STAFF REPORT
COMMUNITY DEVELOPMENT DEPARTMENT

HEARING DATE: 8/16/2022
TO: Mayor & City Council
FROM: Alan Tiefenbach, Associate Planner
208-489-0573
SUBJECT: FP-2022-0022
Skybreak No. 2
LOCATION: 7020 S. Eagle Rd., in the SE ¼ of the
NW ¼ of Section 4, T.2N., R.1E.
(Parcel # S1404233660)

I. PROJECT DESCRIPTION

Final plat consisting of 62 lots and 12 common lots on 11.12 acres of land in the R-8 zoning district.

B. Final Plat (date: 6/02/2022)

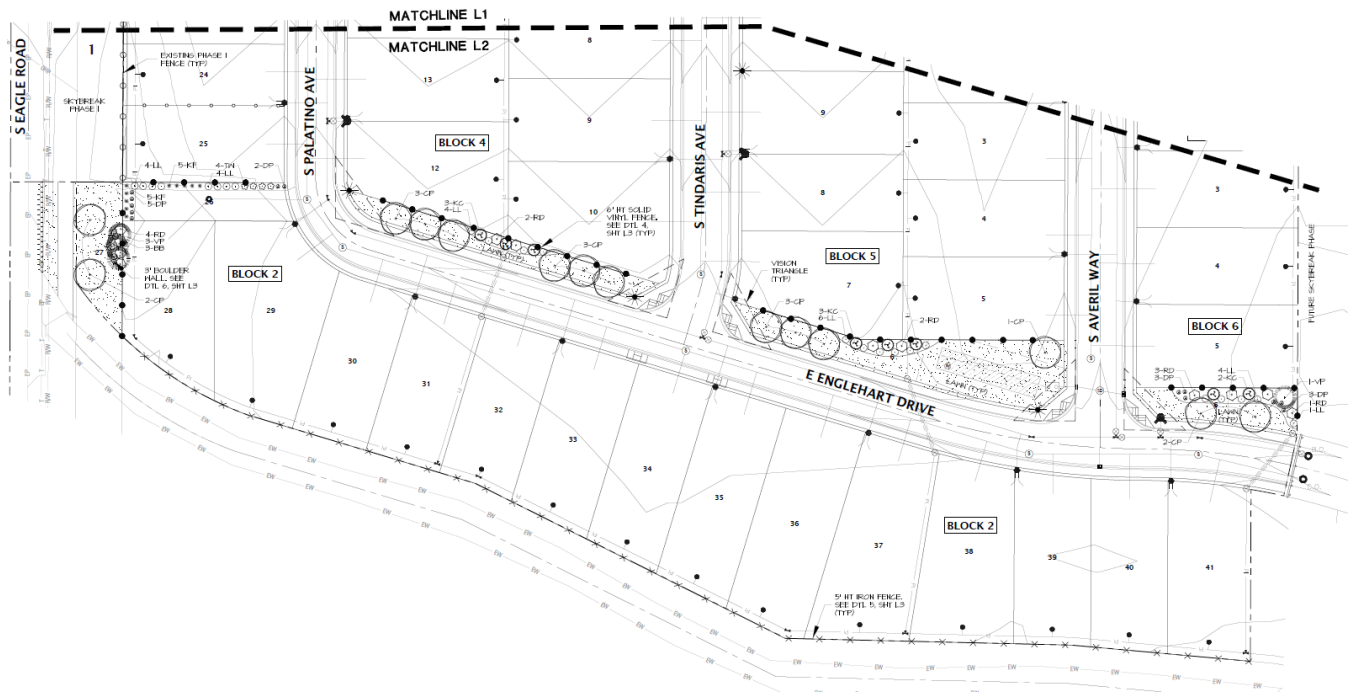
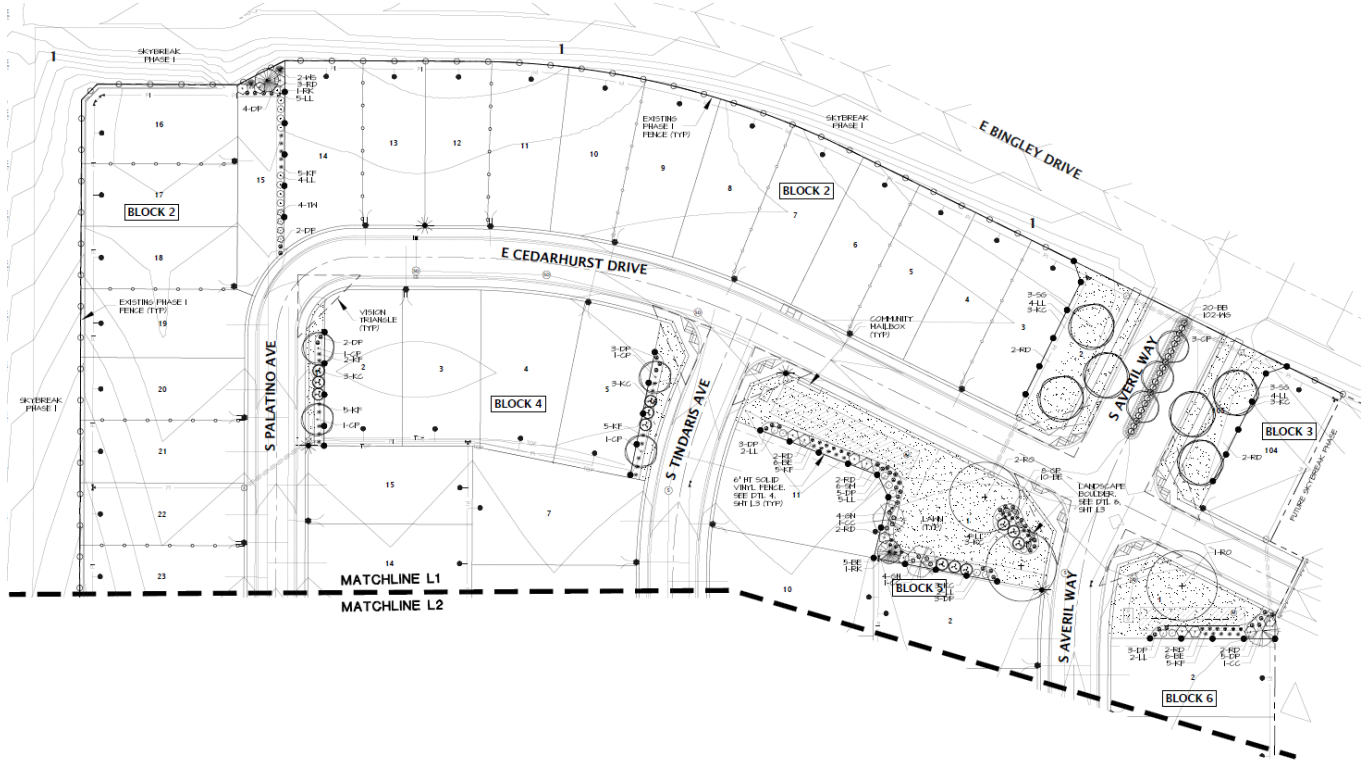
Staff has reviewed the proposed final plat for substantial compliance with the approved preliminary plat in accord with the requirements listed in UDC 11-6B-3C.2. It appears Lot 7, Block 2 does not meet the minimum 40 ft. frontage required in the R-8 zoning district. Otherwise, because the final plat does not increase the number of building lots and/or decrease the amount of qualified open space as shown on the approved preliminary plat, with the exceptions listed above, all lots within the development comply with the dimensional standards listed in UDC Table 11-2A-6 for the R-8 zoning district. Staff finds the proposed final plat is in substantial compliance with the approved preliminary plat as required.

- a. Lot 7, Block 2 shall be revised to meet the minimum lot frontage requirements (40 feet) for the R-8 zoning district per UDC Table 11-2A-6.
 - b. Plat Note No 6 – add instrument number.

- c. Plat Note No. 14 – add instrument number.
 - d. Plat Note No. 15 – add instrument number.
 - e. Plat Note No. 16 – add instrument number
3. Pathways and adjoining fencings and landscaping shall be constructed consistent with the standards as set forth in UDC 11-3A-7A7, 11-3A-8 and 11-3B-12C.

C. Landscape Plan (date: 6/13/2022)

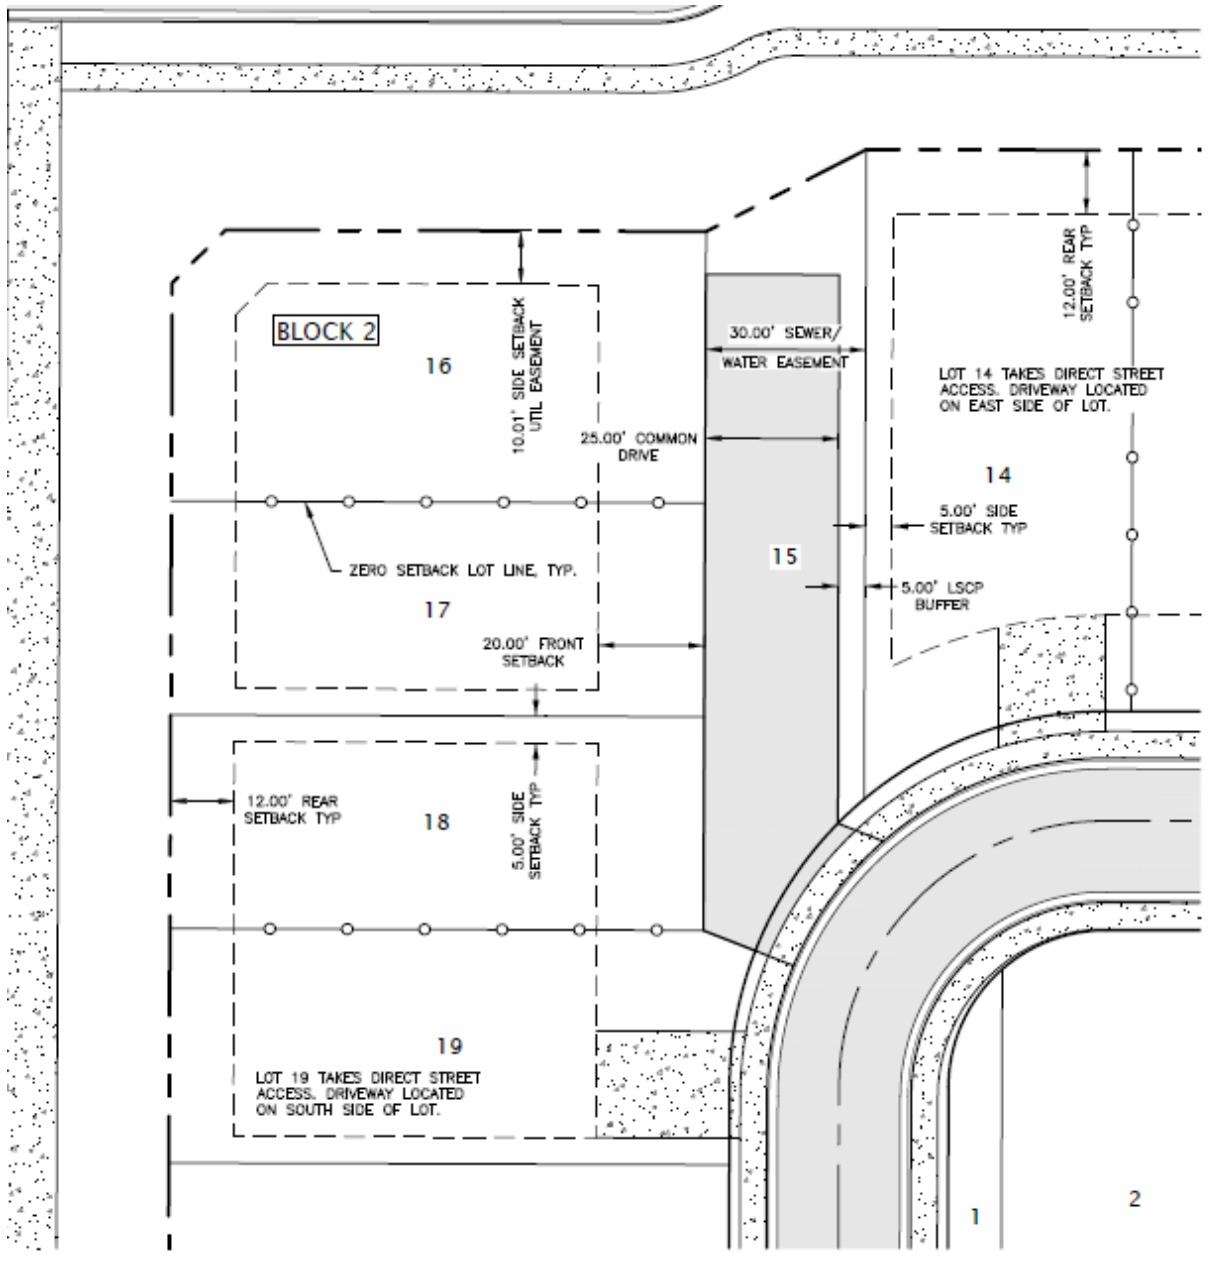
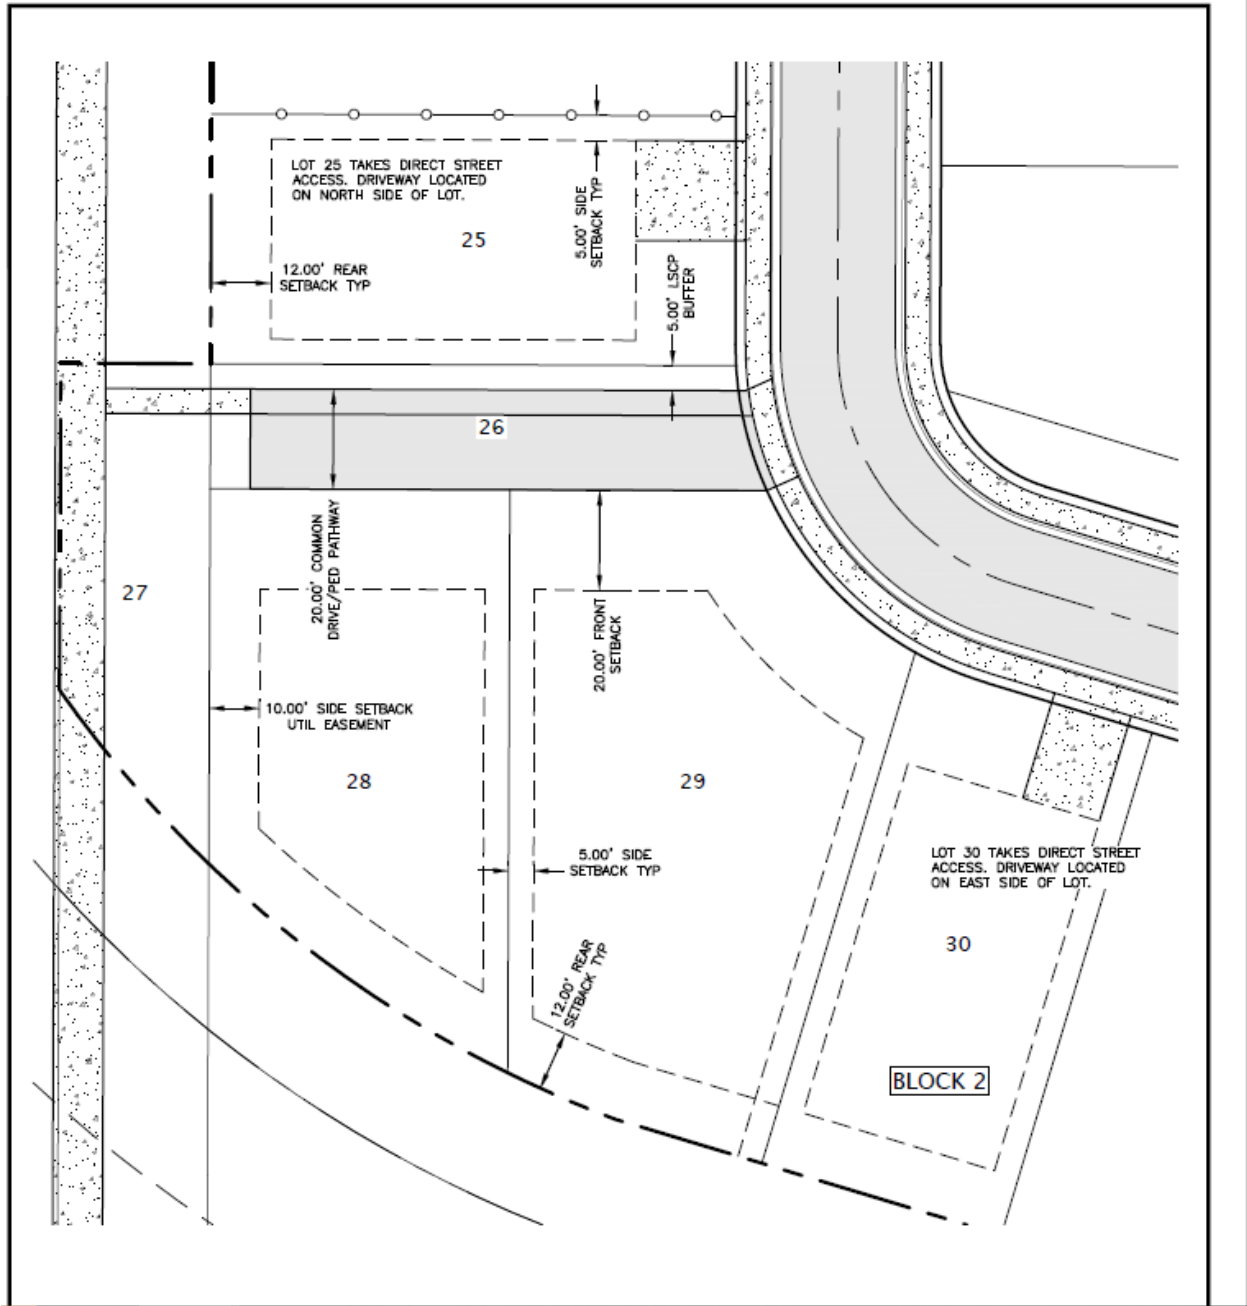
Amenities approved and provided with this plat include an 8,668 sq. ft. common space and several pathway segments. The landscape plan indicates these amenities are landscaped as required per UDC 11-3B-12 and 11-3G.
